ARCHITECTURAL REVIEW BOARD STAFF REPORT

Project #/Name	ARB-2020-19: 2415 Ivy Road Building Permit Review
Review Type	Preliminary review of a Building Permit
Parcel Identification	060000000025A0
Location	2415 Ivy Road near the intersection of Canterbury Road (Figure 1)
Zoned	Commercial (C1)/Entrance Corridor (EC)/Airport Impact Area (AIA)/Steep Slopes - Managed
Owner/Applicant	JPA Tower Investors, LLC/Clark Gathright
Magisterial District	Samuel Miller
Proposal	To renovate 10,000 sf of the street-facing end of the existing commercial building for retail use.
Context	2415 Ivy Road is part of a small group of buildings (including 2405, 2409 and 2411) originally constructed as a John Deere dealership. This portion of Ivy Road is a mixture of commercial (Figure 4) and residential uses. A golf course is to the southwest. The commercial buildings in the vicinity are one and two stories tall.
Visibility	The south, east and west sides of the building are clearly visible from the EC (Ivy Road). The building is 68' from the right-of-way and 82' from the curb.

ROOF PLAN
NOT TO SCALE

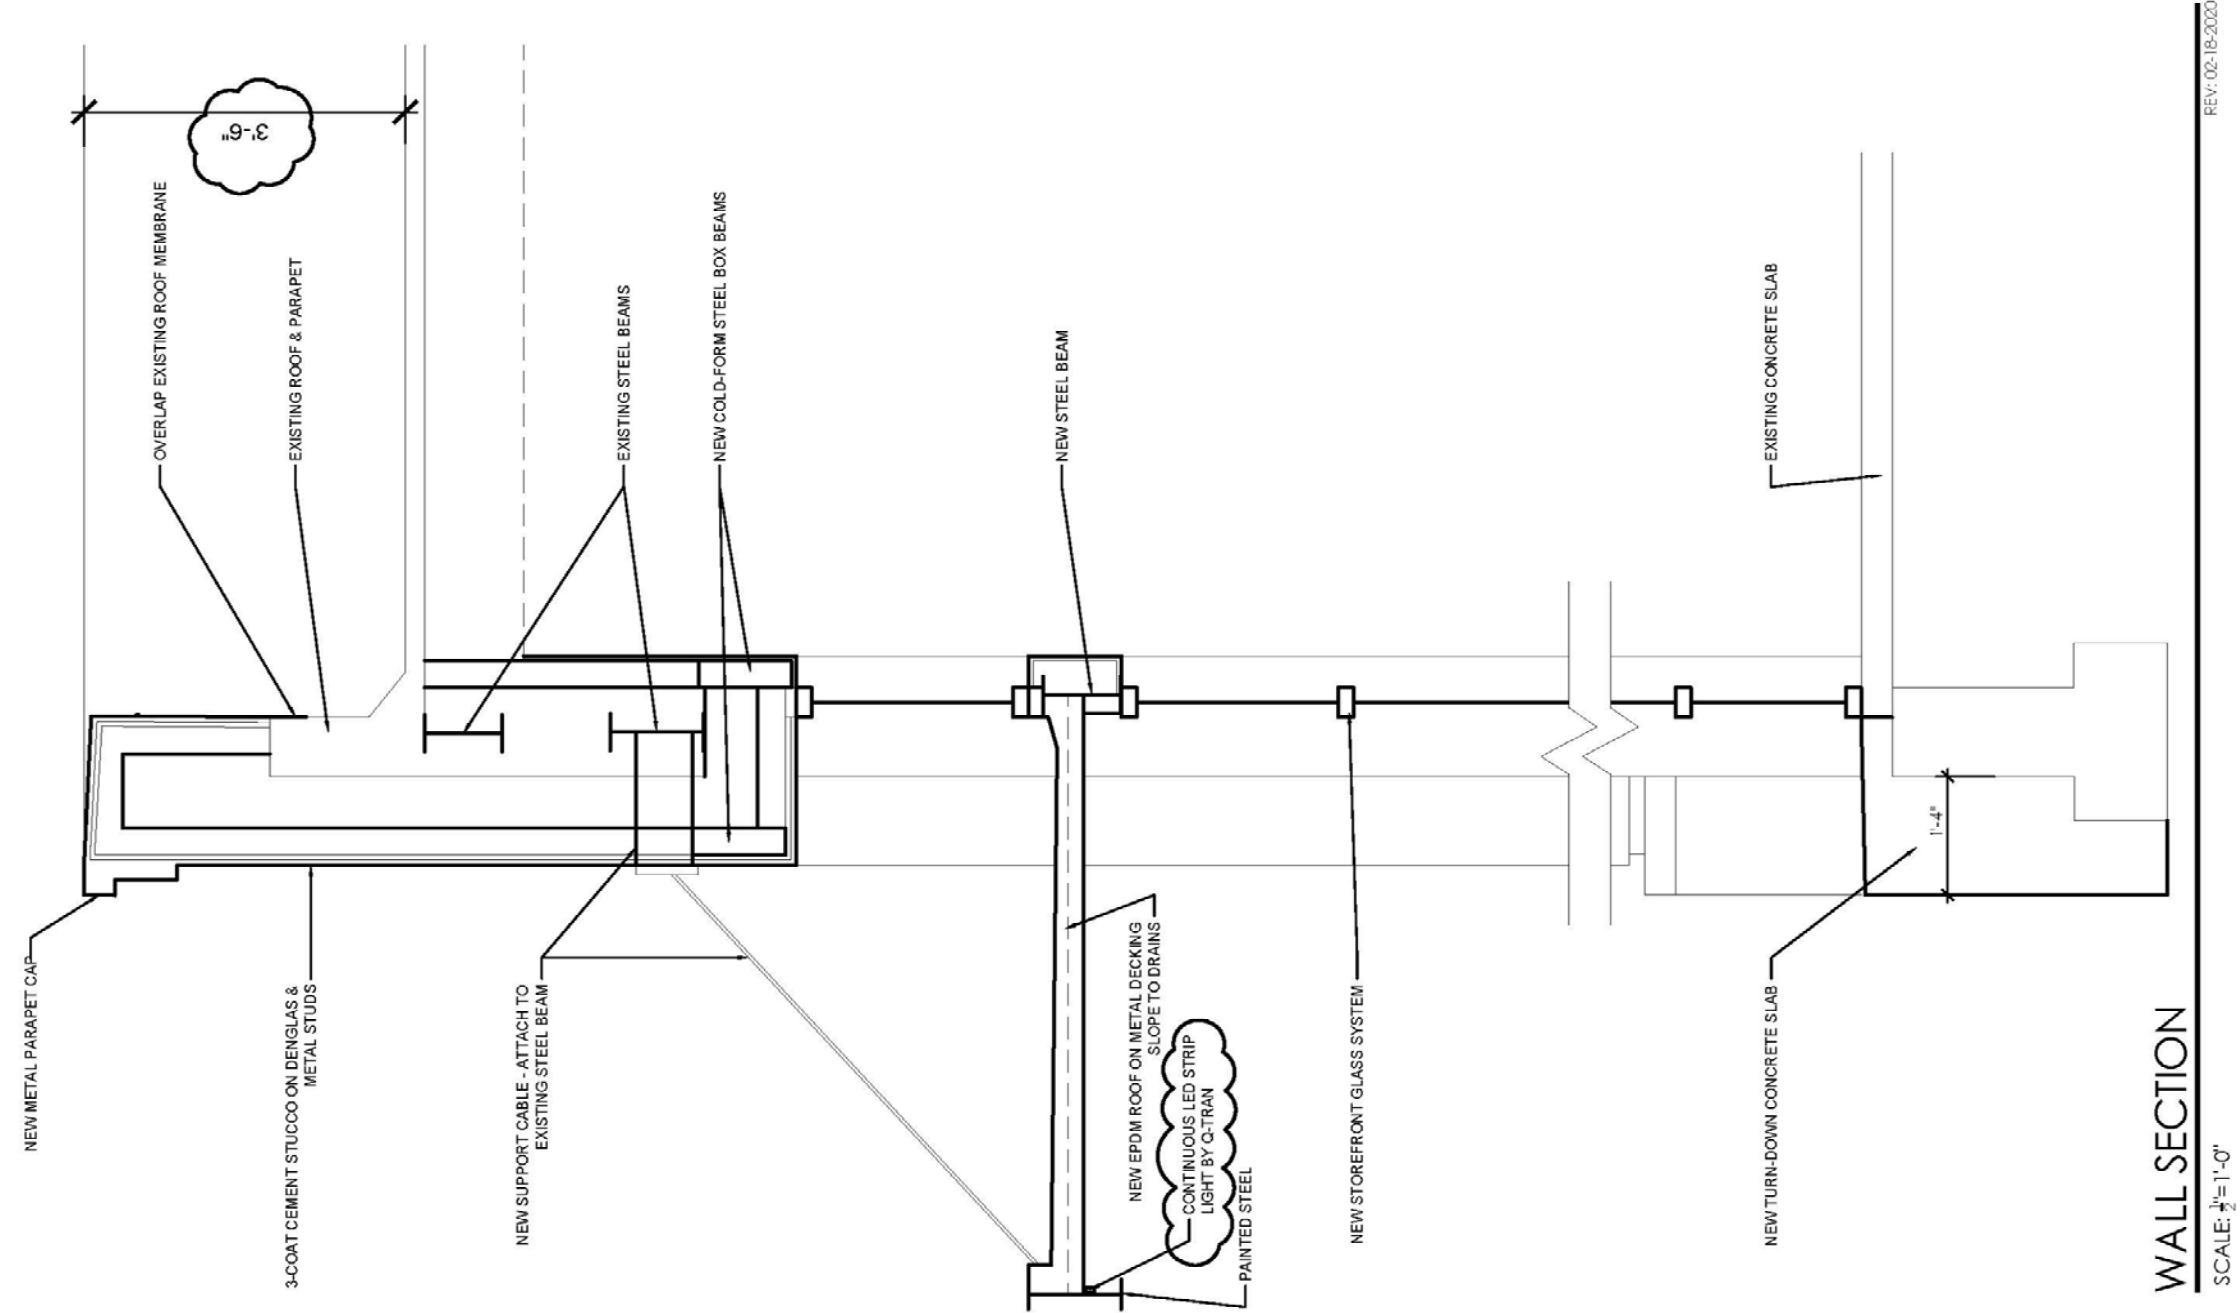
7. Include in the plan whether the existing rooftop mechanical unit near the south end of the building will remain. If it is to remain, revise the Roof Plan and Line of Sight of Mechanical Equipment exhibit to show the unit and ensure that it will no longer be visible from the EC.

LINE OF SIGHT OF MECH. EQUIPMENT

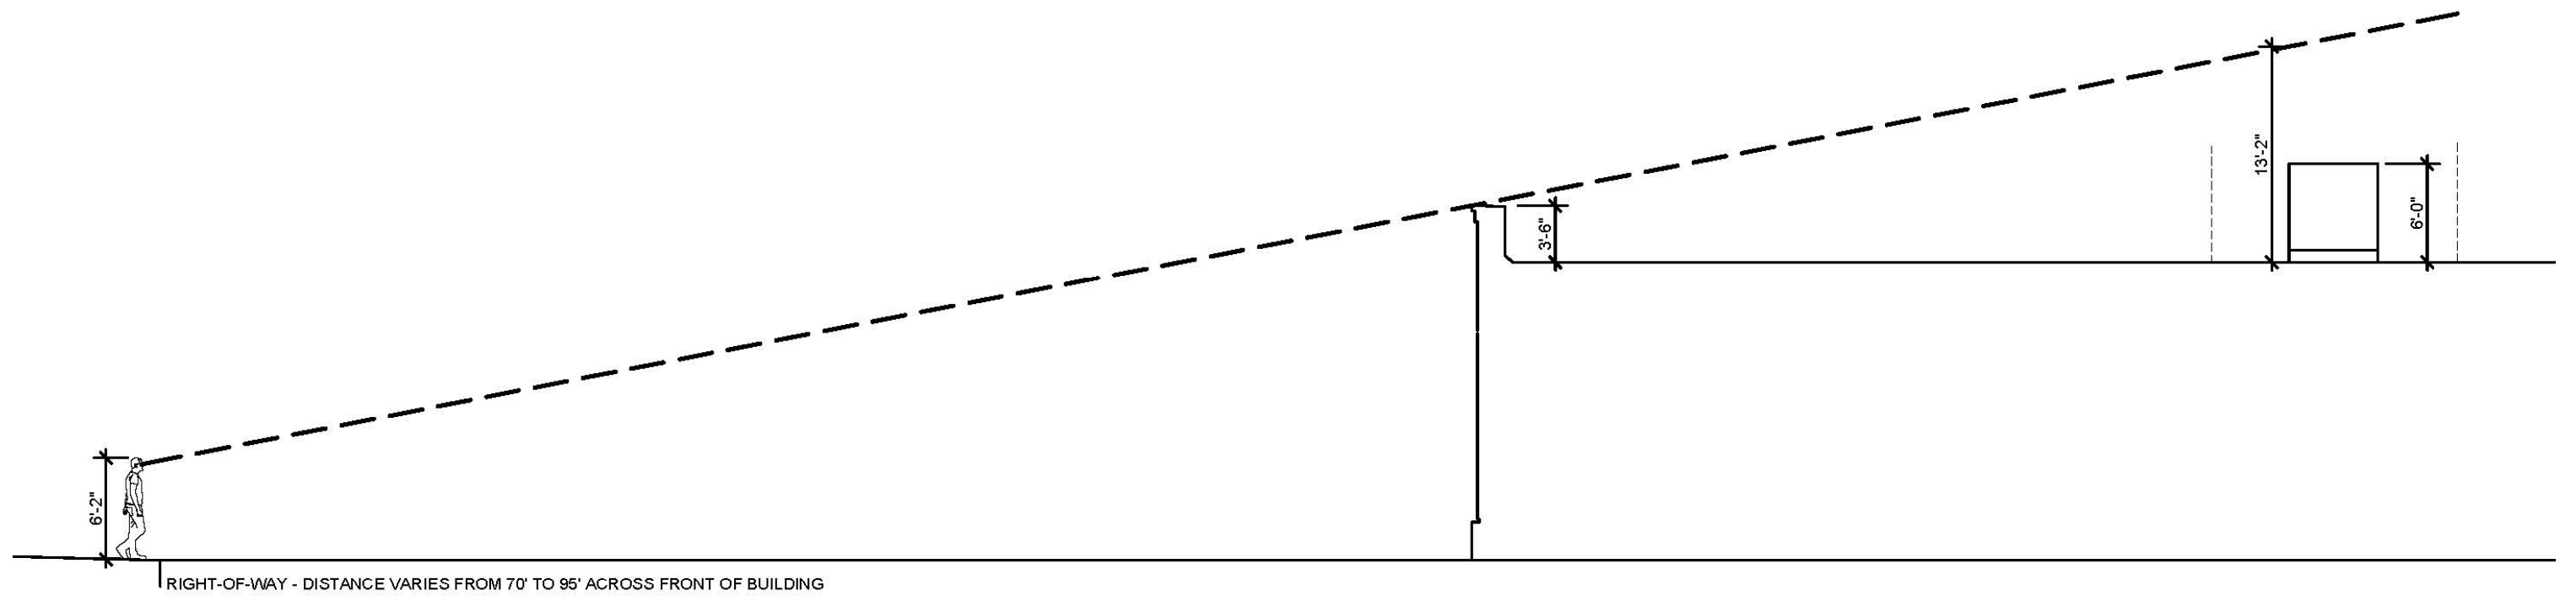
5. Revise the mechanical equipment exhibits to be to scale, utilize all of the same measurements, show the anticipated maximum height of the HVAC units, have the line of sight from the farthest edge of the right-of-way, and provide views from the west and east along the EC.

6. Ensure that the reduced depth of the new parapet extension on the east side of the building will completely screen the proposed HVAC units from the EC.
